Work Order ID 145564

Item Name: Quick Release Basket and Long Cargo Tube Mounting Provisions, Fits LH or RH

DART SERVICE INSTRUCTION

TO AMEND INSTALLATION INSTRUCTIONS D350-607-3 Rev.D,
INSTALLATION INSTRUCTIONS D350-607-4 Rev. C AND
INSTRUCTIONS FOR CONTINUED AIRWORTHINESS ICA-D350-607 REV. 6
REF TCCA STC: SH94-14
REF FAA STC: SR00213NY
REF EASA STC: EASA.10016996
REF BRAZILIAN STC: 2007S03-03/-04/-05/-06

FIGURE 1: INSTALLATION OF D4775-041 FWD STRUT

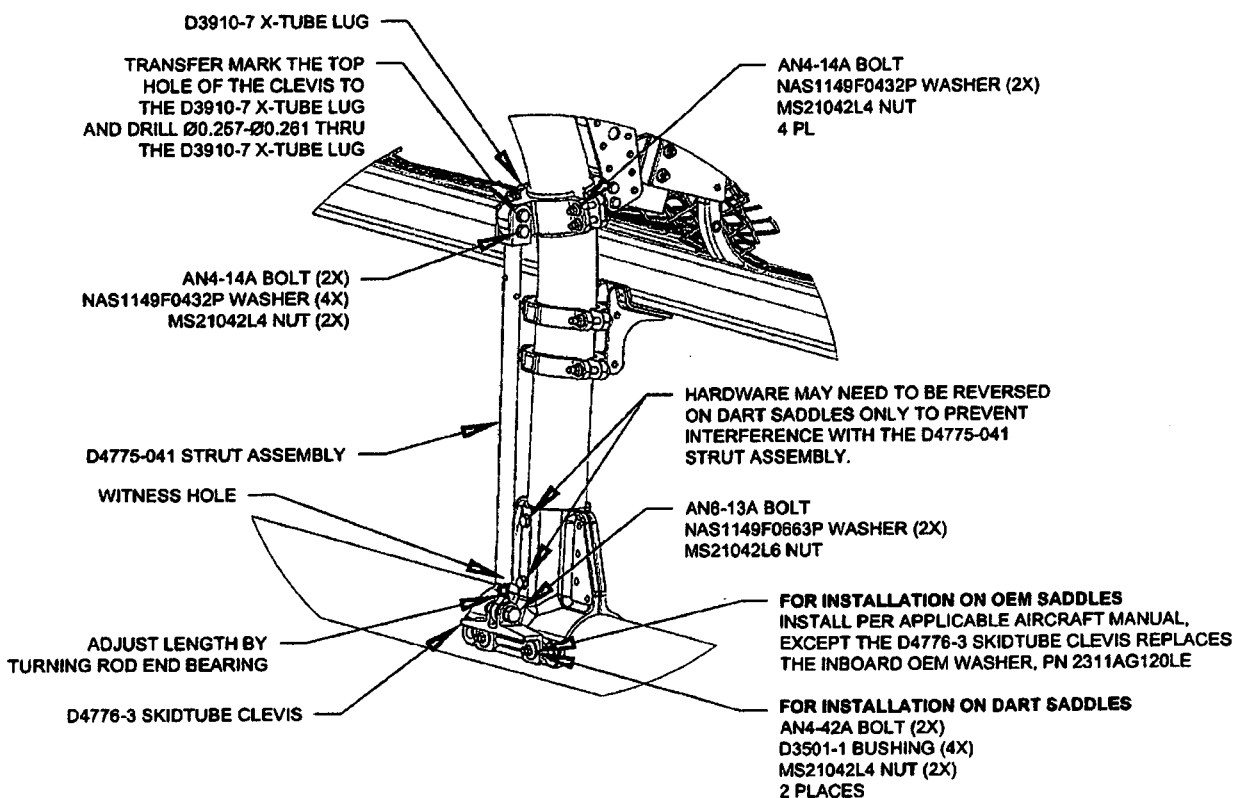
3.1 Substitute the Forward Lower D3910-5 X-Tube Lug with the D3910-7 X-Tube Lug as shown in Figure 1.

3.2 Install the forward D4775-041 Strut Assembly. Transfer mark from the upper hole on the clevis of the D4775-041 Strut Assembly to the D3910-7 X-tube Lug and drill thru the lug $\varnothing 0.257 - \varnothing 0.261$ as shown in Figure 1. Touch up chemical conversion coating per MIL-DTL-5541. Check the witness holes located at the bottom end of the D4775-041 Strut Assemblies to ensure that the thread from the rod end extends past the witness hole.
Torque MS21042L4/-4 nuts to 50-70 in-lbs (5.7-7.9 N-m). Torque MS21042L6/-6 nuts to 160-190 in-lbs (18.1-21.5 N-m).
